AMENDMENT OF SOLICITATION/MODIFICATION OF CONTRACT			1. Contract Number	Page of Pages 1 22	
2. Amendment/Modification Number GF-2010-B-0006-004		3. Effective Date 7-May-10		4. Requisition/Purchase Request No.

14. Description of amendment/modification (Organized by UCF Section headings, including solicitation/contract subject matter where feasible.)					
Solicitation No. GF-2010-B-0006, Renovation of Plaza Deck and Parking Garage is hereby amended as follows:

ANSWERS TO OFFERORS QUESTIONS

PARTIAL DWG. E-3

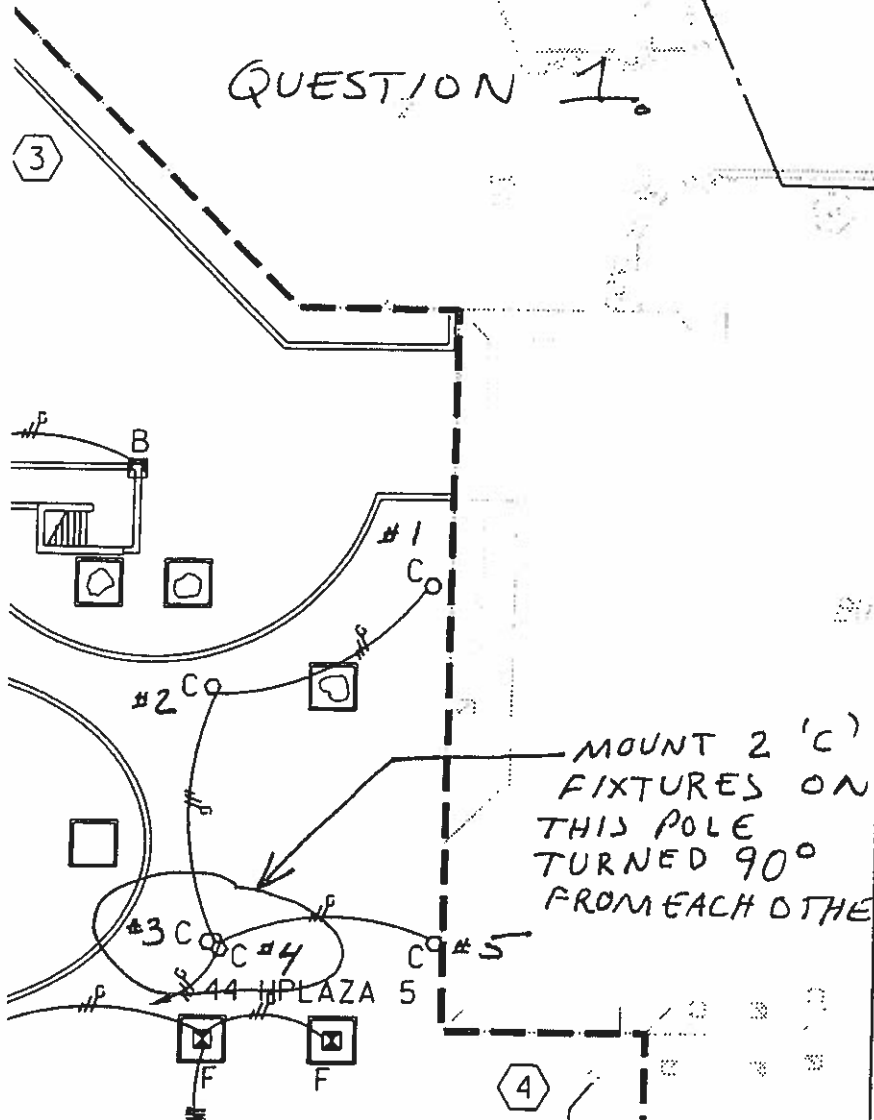
Quest No.	Question	Answer
1.	<p>Reference Site Lighting Plan Sheet E-3, Material and Layout Enlargement Plans L-2 & L-3, and Site Detail Plan LD-15 Detail #4. The Light Fixture Schedule on sheet E-3 states that there is a quantity of 5 type "C" light fixtures required for this project. Site lighting plan E-3 and landscape plans L-1 & L-2 show only 4 type "C" light fixtures. Which quantity is correct? If a total quantity of 5 is required. Where is the 5th type "C" light fixture locate? Please clarify.</p>	<p>5 is the correct quantity of type "C" light fixtures. See attached enlargement of drawing E-3 for locations.</p>

QUESTION 1.

PARTIAL DWG. E-3

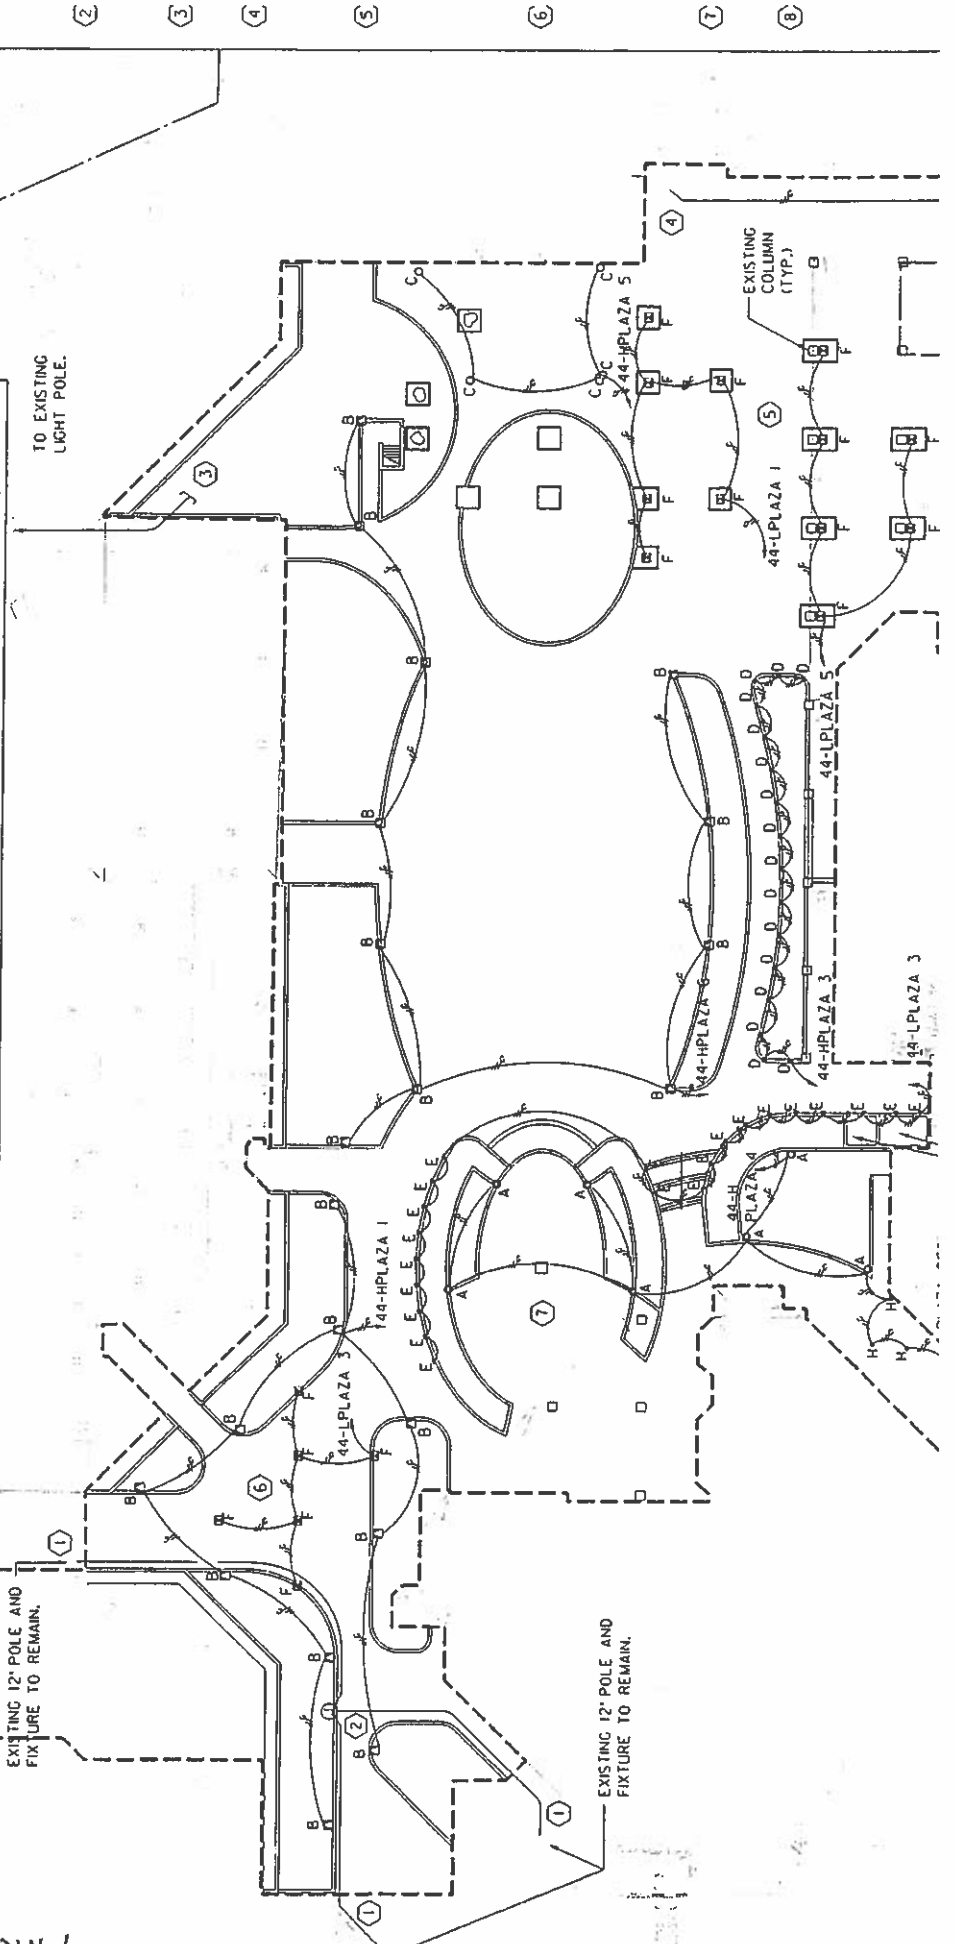
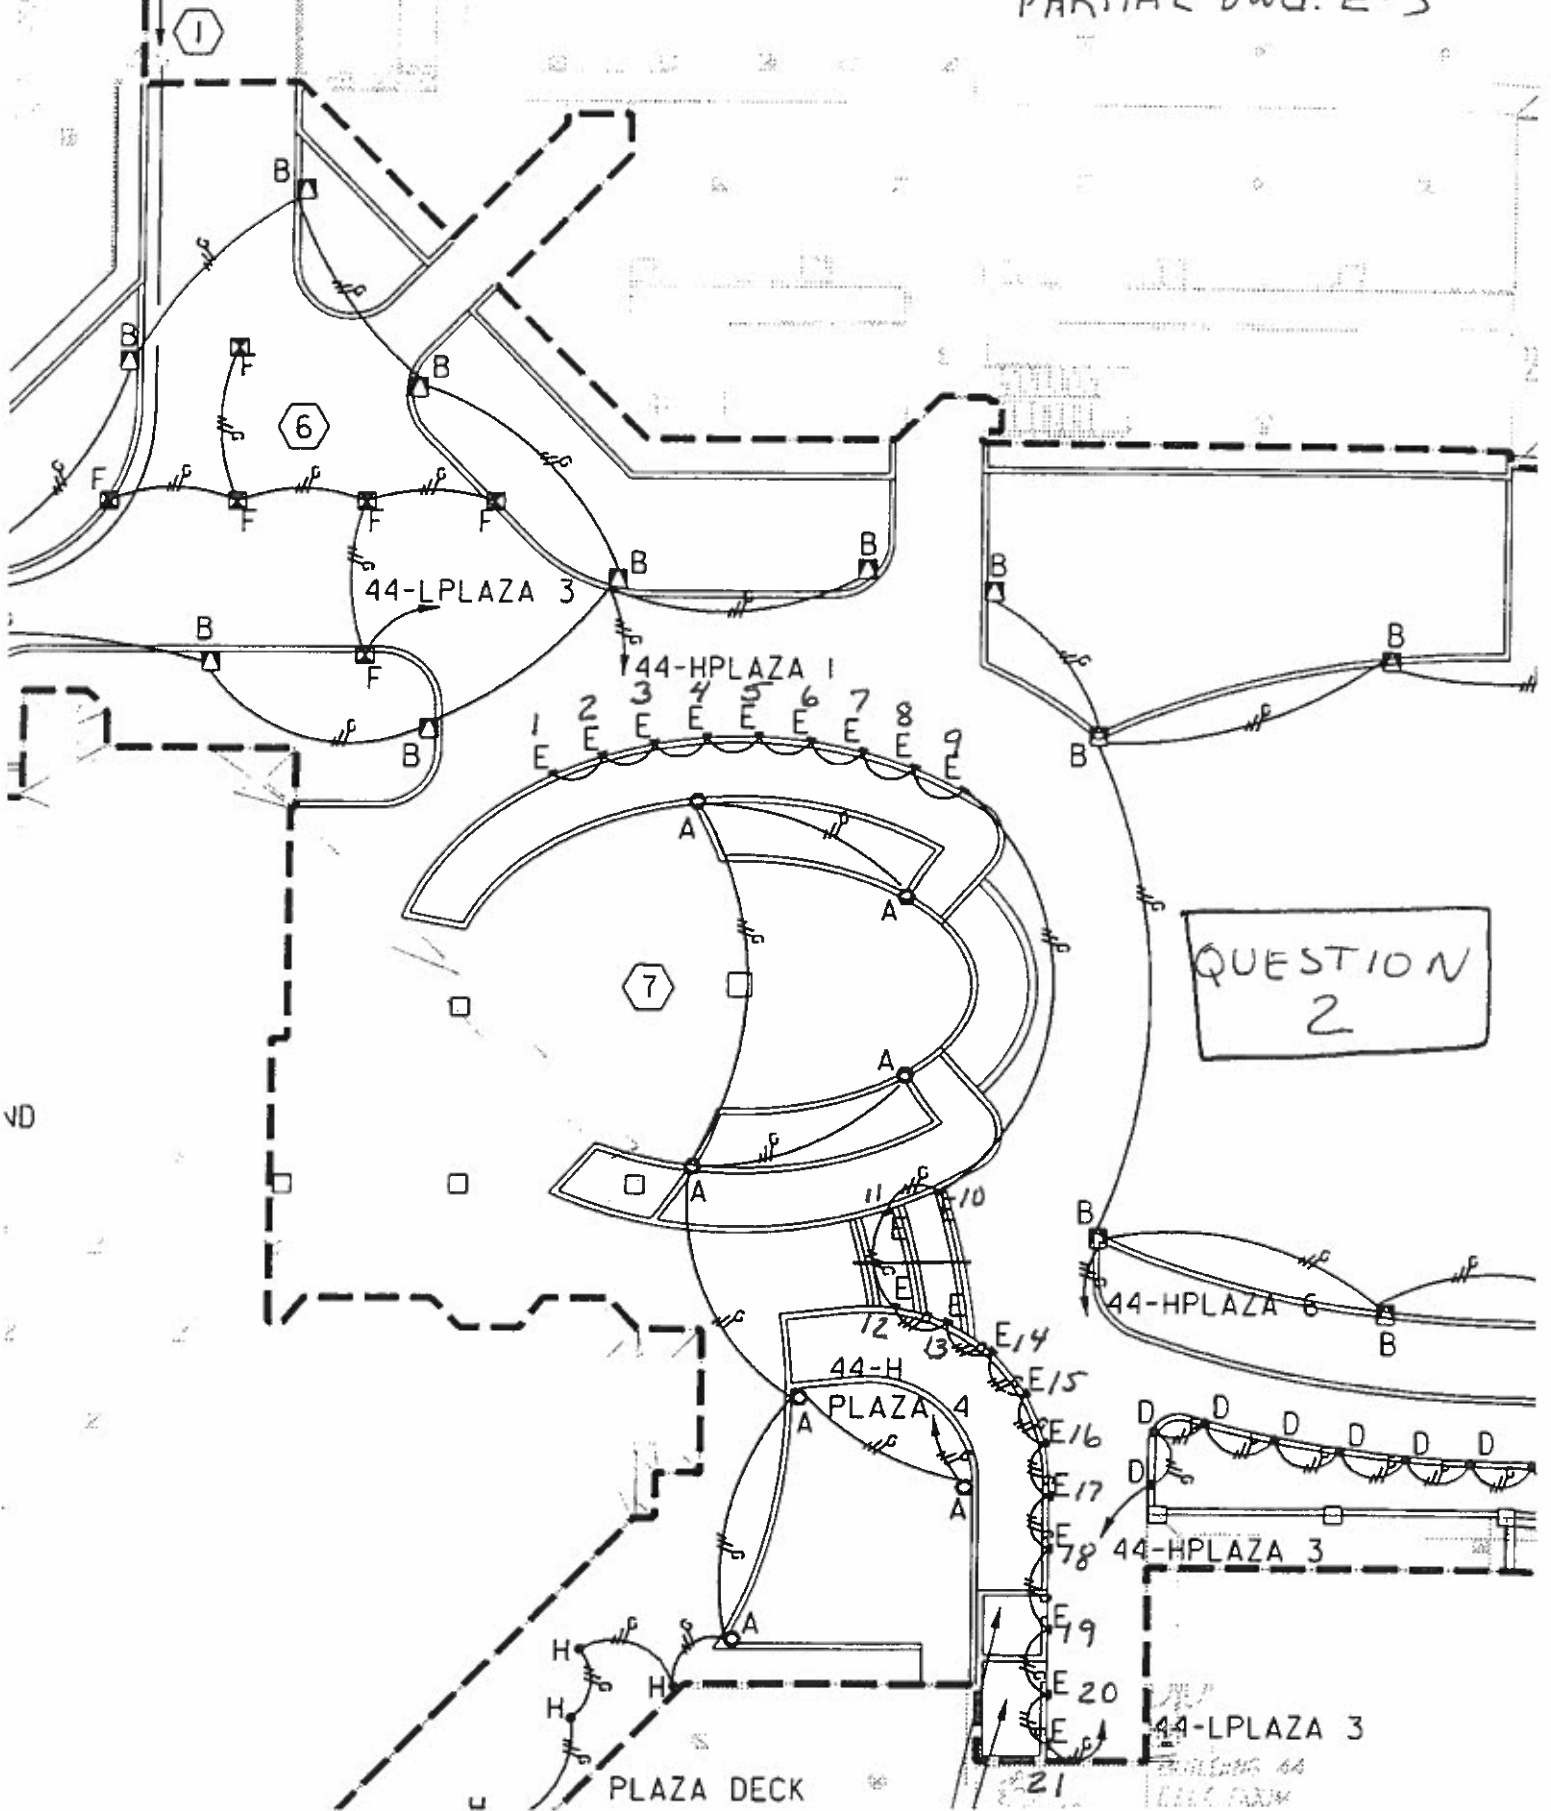
2.	<p>Reference Site Lighting Plan Sheet E-3 and Material and Layout Enlargement Plans L-4 & L-5. The Light Fixture Schedule on sheet E-3 states that there is a quantity of 28 type "E" light fixtures required for this project. Site lighting plan E-3 and landscape plans L-3 & L-4 show 21 type "E" light fixtures. Which quantity is correct? Please provide the location of the other 7 type "E" light fixtures.</p>	<p>21 is the correct number of type "E" light fixtures. See attached enlargement of drawing E-3.</p>

QUESTION 2

QUESTION
2

QUESTION 3
PARTIAL E-6

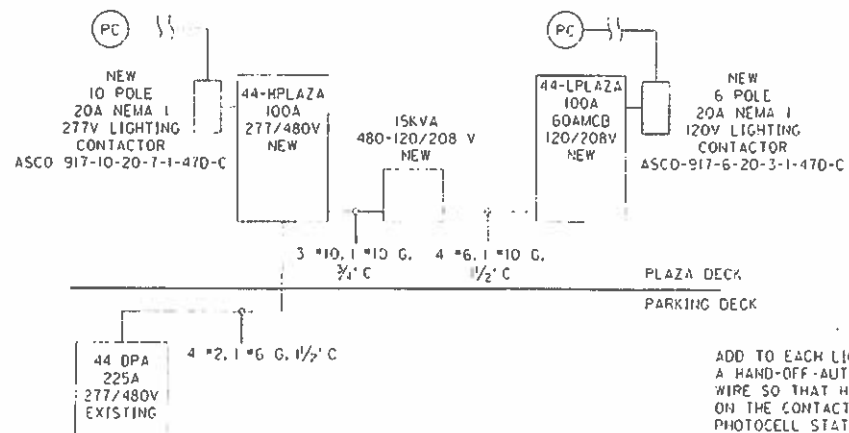
3.	<p>The single line diagram on sheet WE-4 states that the feeder for the Fountain Power Distribution Center is to be specified by others. Is the feeder for this equipment part of this contract? If so, what size is the feeder and where is it fed from? Please clarify.</p>	<p>WE-4 says "SEE DWG. E-6". Drawing E-6 shows a 150A feeder breaker to be added to CKTS 7, 9, 11 in existing panel 41-DPA. Feeder cable is shown to be 4 # 1/0, 1 # 6 ground, 2" conduit. See drawing E-6, attached (partial).</p>

ADD BREAKER.

150 AMP BREAKER FOR FOUNTAIN EQUIPMENT SHALL BE SHUNT TRIP. CONNECT SHUNT TO THE FLOAT SWITCH PROVIDED WITH THE FOUNTAIN EQUIPMENT. RISING WATER SHALL TRIP THE BREAKER, KILLING POWER TO THE FOUNTAIN EQUIPMENT.
